HISTORIC AND DESIGN REVIEW COMMISSION

HDRC CASE NO: 2019-672
ADDRESS: 245 LOSOYA ST
LEGAL DESCRIPTION: NCB 914 BLK LOT 11 (RIVER RESTAURANTS SUBD)
ZONING: D, H, RIO-3
CITY COUNCIL DIST.: 1
DISTRICT: Alamo Plaza Historic District
LANDMARK: Farnsworth Building
APPLICANT: Edward Moser/River Restaurants, Ltd.
OWNER: William Lyons/LOS LEONES FAMILY LTD PRTSHP
TYPE OF WORK: Installation of an awning at the street level on the River Walk facade
APPLICATION RECEIVED: October 22, 2019
60-DAY REVIEW: December 21, 2019
CASE MANAGER: Edward Hall

REQUEST:

The applicant is requesting a Certificate of Appropriateness for approval to install a metal awning on the River Walk façade at the street level. The proposed awning will feature sixty-six (66) feet in length, approximately fifteen (15) feet in height, and nine (9) feet in width.

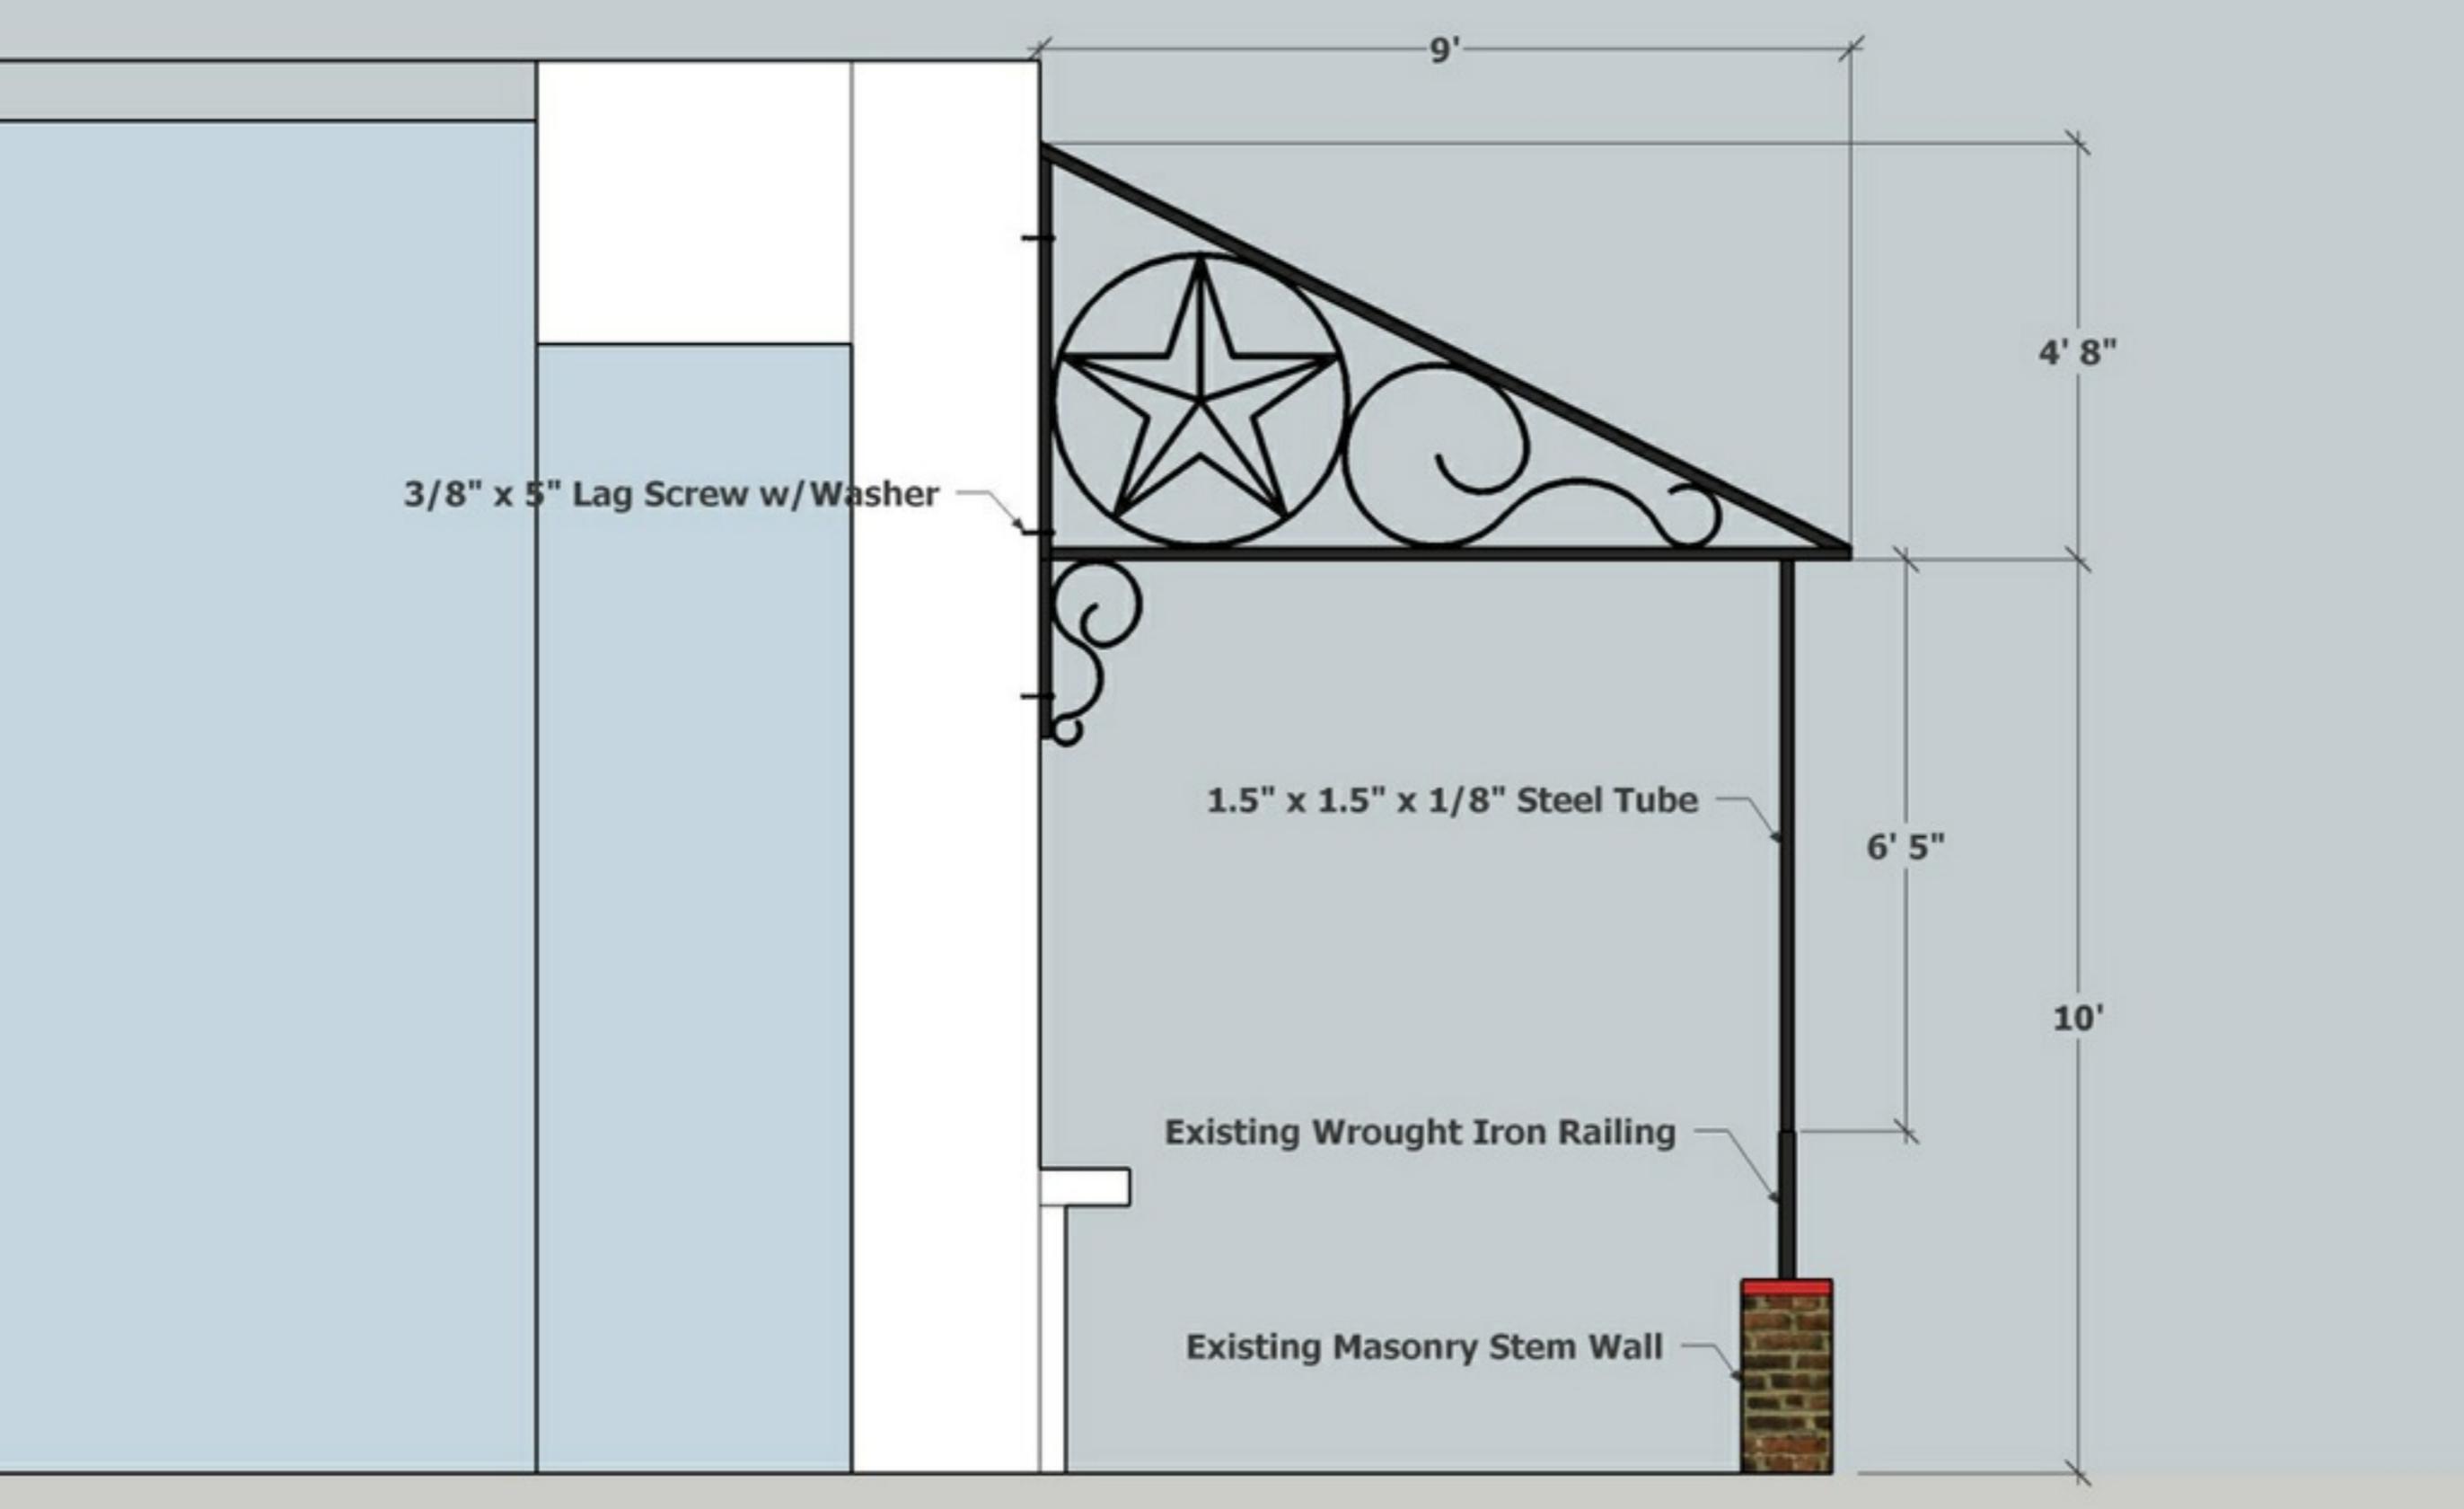
such evidence exists, the design of new canopies and awnings should be based on the architectural style of the building and be proportionate in shape and size to the scale of the building façade to where they will be attached. Staff finds that the location of the proposed awning does not alter or obscure any original historic building fabric. However, staff finds that the proposed design is not in keeping with the architectural style of the building and should be simplified to remain visually unobtrusive.

Staff recommends approval based on the findings with the stipulation that the applicant simplify the proposed design. This includes simplifying the proposed scrollwork and bracket detail in favor of a more compatible design.
